ADDENDUM NO. 4 TO PROJECT NO. 44225

ELECTRICAL WORK

**PROVIDE PEDESTRIAN SALLYPORT,
FENCING AND SECURITY MODIFICATIONS
MOHAWK CORRECTIONAL FACILITY
6514 STATE RTE. 26, ROME, N.Y.**

February 02, 2012

C-103A

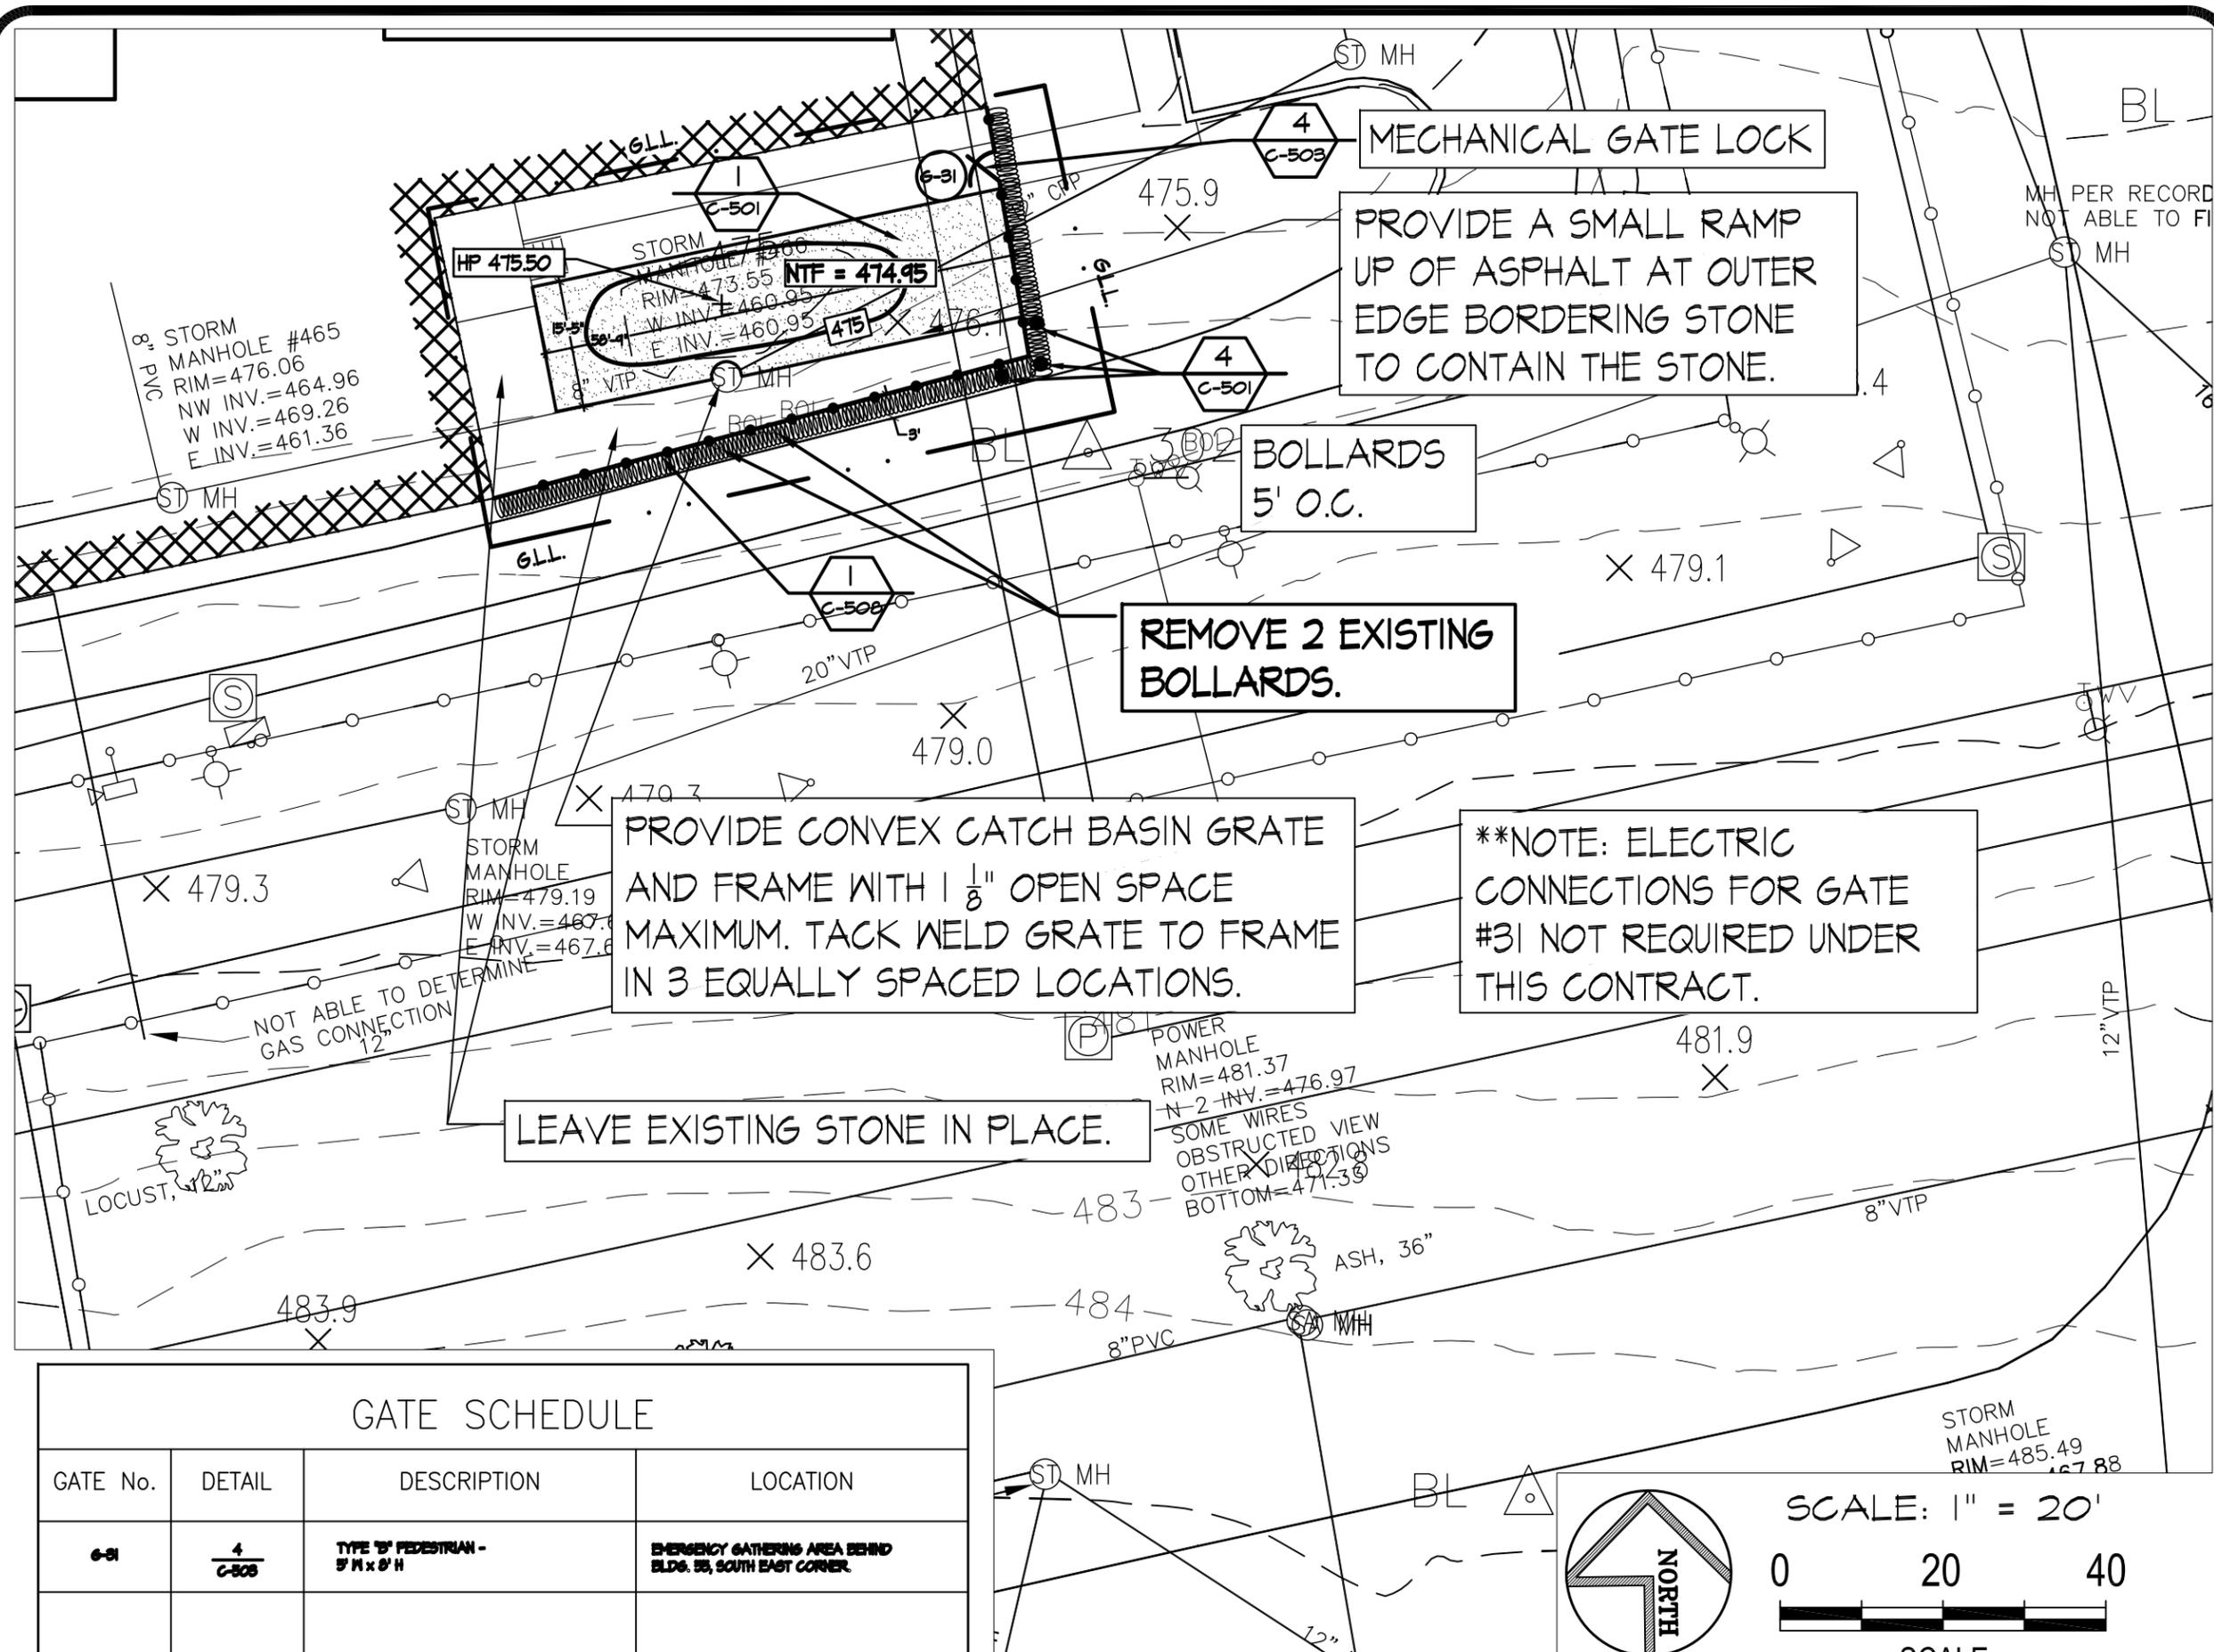
1. DRAWING G001 (COVER SHEET):
 - a. GENERAL SECURITY NOTES, add the following subparagraph to Note A:
“2. ALL WORK AREAS FOR THIS PROJECT SHALL BE CONSIDERED AS SECURE AREAS AND ALL REQUIREMENTS OF SECTIONS 015633 AND 015634 SHALL APPLY TO ALL WORK AREAS.”
2. DRAWING C-103:
 - a. Site Plan: change the note that reads:
“REMOVE EXISTING STONE, PLACE SEPARATION FABRIC, AND REPLACE WITH 6” RIVER STONE MEETING A #5 GRADATION AS SEEN ON DOT TABLE 703-4 SIZES OF STONE, GRAVEL AND SLAG.”
to read:
“PROVIDE SECURITY FENCE AND RELATED WORK AS SHOWN ON DRAWING No. C-103A.
3. ADD DRAWING No. C-103A,
 - a. Add drawing C-103A, titled “PARTIAL SITE PLAN”. This drawing is attached to this Addendum and becomes part of the bid documents.
4. ADD DRAWING No. C-508,
 - a. Add drawing C-508, titled “DETAIL FOR NEW CONTROL FENCE”. This drawing is attached to this Addendum and becomes part of the bid documents.
